ROBERT BARNES SUBDIVISION

APPLICATION NUMBER 7 DATE May 1, 2003
APPLICANT Robert Barnes Subdivision
REQUEST Subdivision

ROBERT BARNES SUBDIVISION

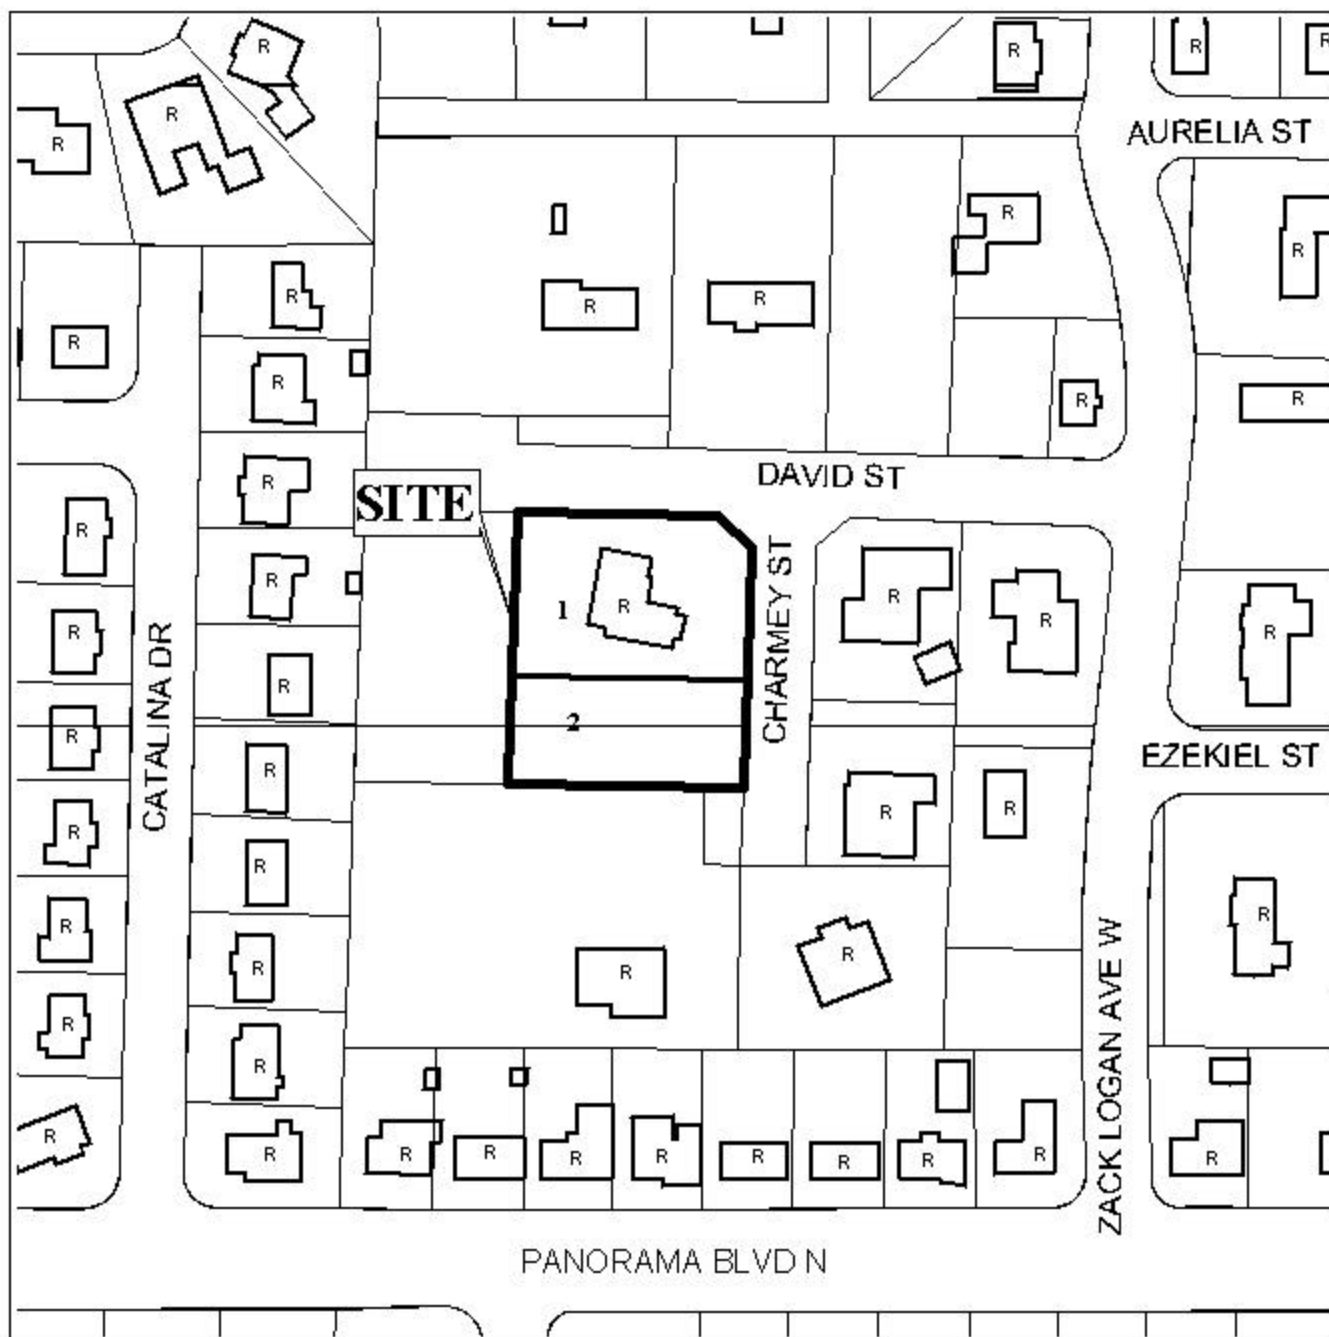
Engineering Comments: Radius at the intersection of David Street and Charmey Street not specified on the preliminary plat. Request dedication to meet standard of 25-foot radius if it does not meet the standard. Development of property must comply with all stormwater management and flood control ordinances. Any work performed in the right-of-way will require a right-of-way permit.

Traffic Engineering Comments: Driveway number, size, location and design to be approved by Traffic Engineering and conform to AASHTO standards.

As illustrated on the Vicinity Map, Lot 1 has road frontage on David Street and Charmey Street; therefore, a note should be placed on the final plat stating that Lot 1 is limited access from the existing curb cut to David Street.

The plat meets the minimum requirements of the Subdivision Regulations and is recommended for Tentative Approval subject to the following conditions: 1) dedication of a minimum 25-foot radius at the Southwest corner of David Street and Charmey Street to be approved by City Engineering; and 2) the placement of a note on the final plat stating that access to Lot 1 is limited to the existing curb cut to David Street.
